81142A-01-S

S E R V I C E N O T E

Product Number: 81142A High Speed Pulse Generator

POSSIBLE FIRE HAZARD

The following photo illustrates the layout of the instrument. It shows the polypropylene molding, the graphics card and the starting point of the fire.

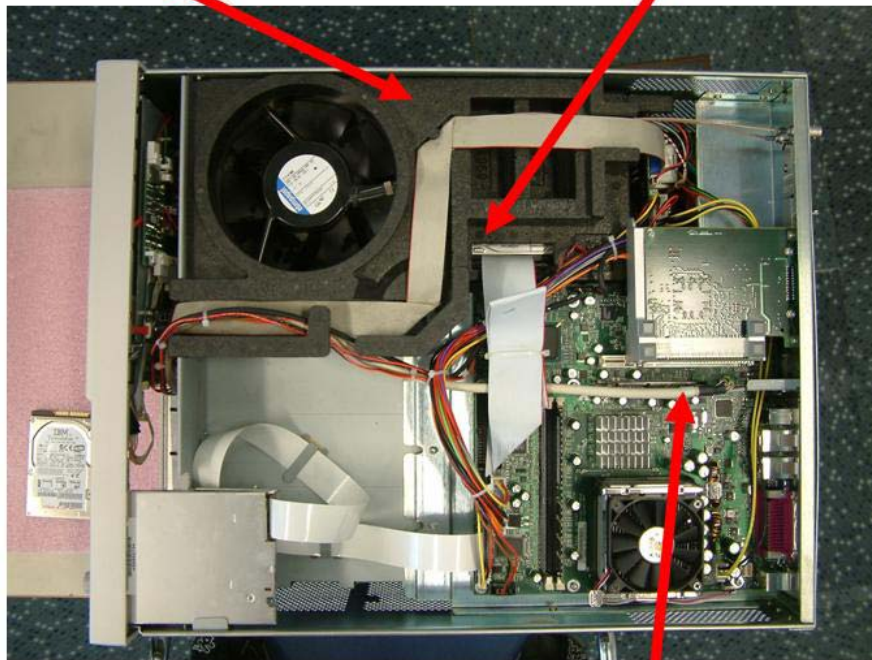
A surface-mount ceramic capacitor suffered physical stress during the manufacturing process, leading the capacitor to crack. During operation this crack placed stress on the internal structure of the capacitor, and caused the plates to short together. (The plates are separated by very little space, made up of very thin insulators.) This caused the capacitor to have very low residual impedance, resulting in a very high current conducted through the capacitor and the 12V path on the motherboard for some period of time. The low impedance didn't lead to a current high enough for blowing the fuse. Therefore the higher current was available long enough to create a very high temperature ($T > 300^{\circ}\text{C}$). The high temperature ignited the polyurethane molding used to conduct the airflow for cooling through the instrument.

Polypropylene Molding

Start of Fire

Graphics Card

The countermeasure for this issue is to exchange the graphics cards. The new graphics cards are produced with an improved manufacturing process eliminating the risk of micro cracks and have additional fusing to protect the 12V path. The graphics card can be exchanged by Agilent authorized personnel only.
